# Access Compliance Report

## Public Rights-of-Way

### (Pedestrian Signals)

Intersection ID: N/A	Main Street:	Cross Street: N/A	Location: N/A
ADA ID: 1C7B10EEE691	Signal Type: One Push Button-Non APS	Overall Compliance: No	Severity Score: BTN 1: N/A BTN 2: N/A No BTN: N/A
Codes/Mitigation Info/Possible Solution		Field Measurements/Component Compliance

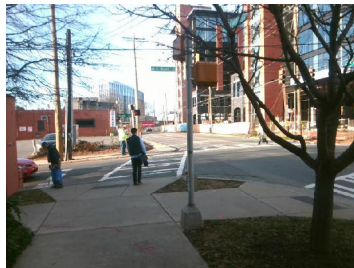
PROW/ADA: TMUTCD 4e.08, R406.2

Yes	B 1 Clear Xing Direction?	ClearlyMarked	N/A	B 2 Clear Xing Direction?	N/A
	B 1 Crossing Direction	To NW		B 2 Crossing Direction	N/A
Yes	B 1 DistanceTo XWalk (in)	0.0	N/A	B 2 DistanceTo XWalk (in)	N/A
No	B 1 DistanceTo Curb (in)	156.0	N/A	B 2 DistanceTo Curb (in)	N/A
Yes	B 1 Diameter (in)	2.0	N/A	B 2 Diameter (in)	N/A

Possible Solutions: Replace Signal Push Button With APS Button on New Post. Remove & Relocate Sign.
